**COMMONWEALTH OF VIRGINIA
STATE CORPORATION COMMISSION**

VIRGINIA ELECTRIC AND POWER COMPANY

**For approval and certification of the Coastal Virginia
Offshore Wind Commercial Project and Rider Offshore
Wind, pursuant to § 56-585.1:11, § 56-46.1, § 56-265.1 *et
seq.*, and § 56-585.1 A 6 of the Code of Virginia**

PUR-2021-00142

Figure 1: Basic CVOW Commercial Project Components

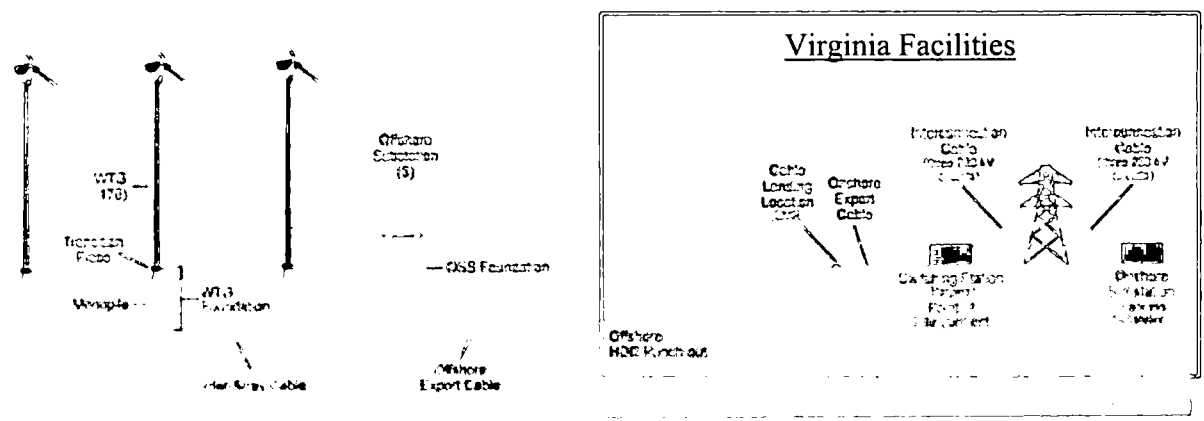
3 A. The Virginia Facilities are shown in the red frame in the figure below.⁹⁵

⁹⁶ To add clarity, Staff reiterates that this amount covers the work that would begin from the Punch-out approximately 1,800 feet offshore, not 3.0 miles offshore as one could infer from page 7 of the Application.
